ISO/IEC/
IEEE
8802-3

**AMENDMENT 6: Maintenance #13:
Power over ethernet over 2 pairs**

Reference number
ISO/IEC/IEEE 8802-3:2021/Amd.6:2021(E)

Abstract: This amendment to IEEE Std 802.3-2018 makes technical and editorial corrections and refinements to Power over Ethernet over 2-pairs in Clause 33.

Figure 33–16—PD state diagram

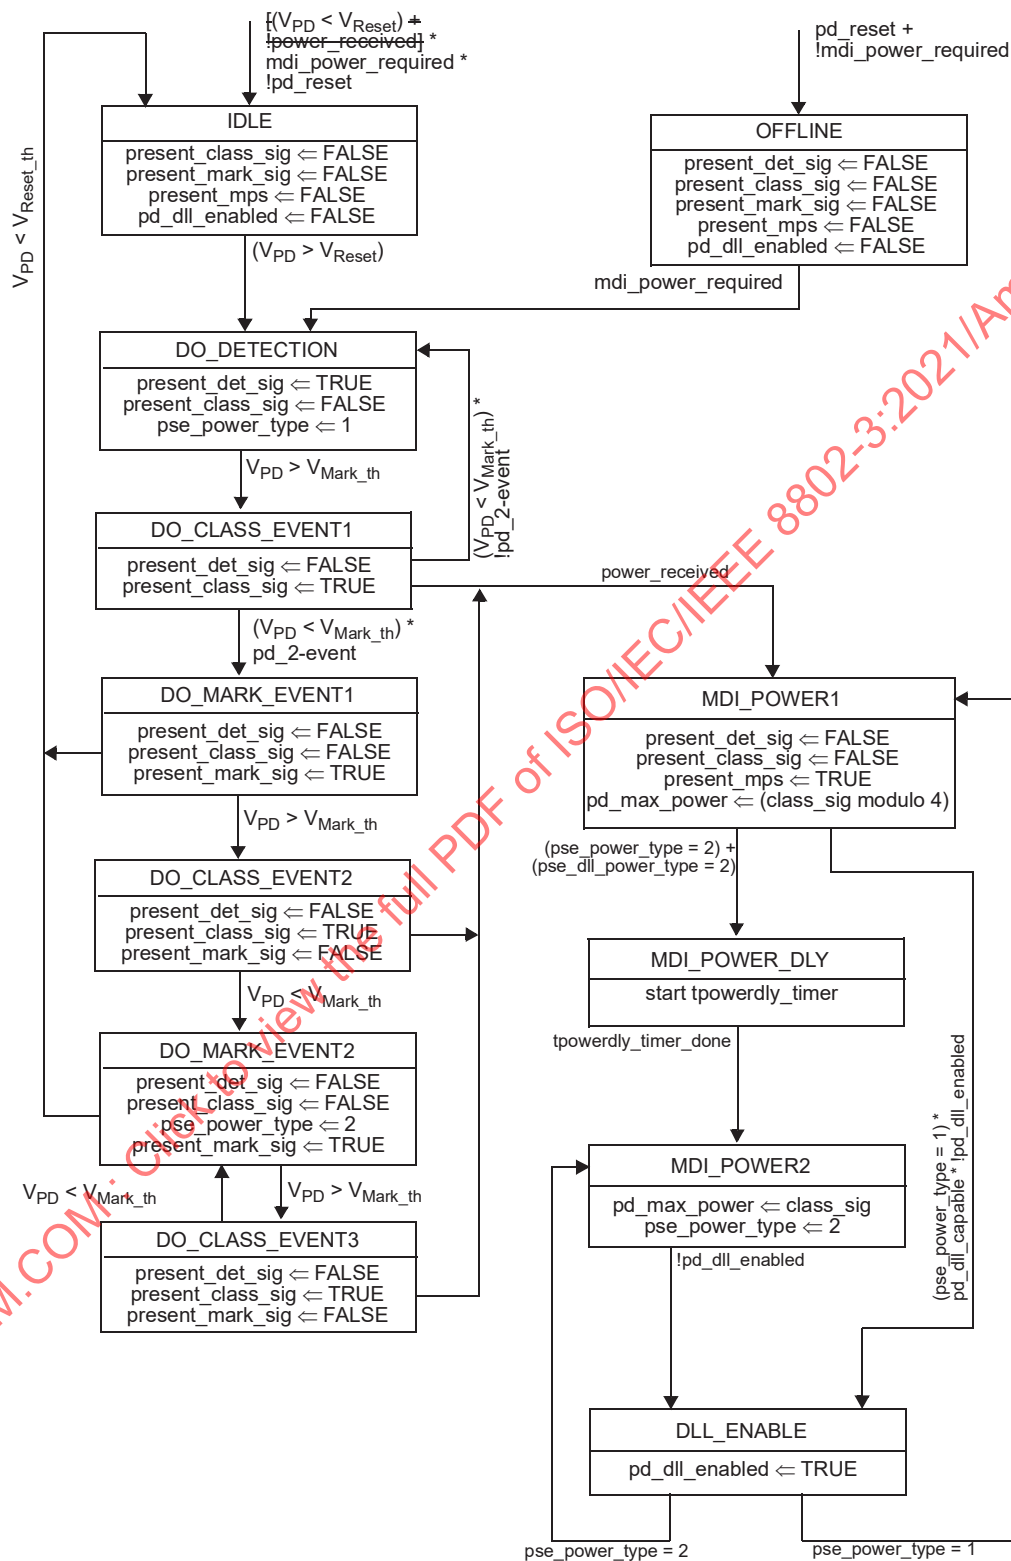
Change Figure 33–16 as follows:
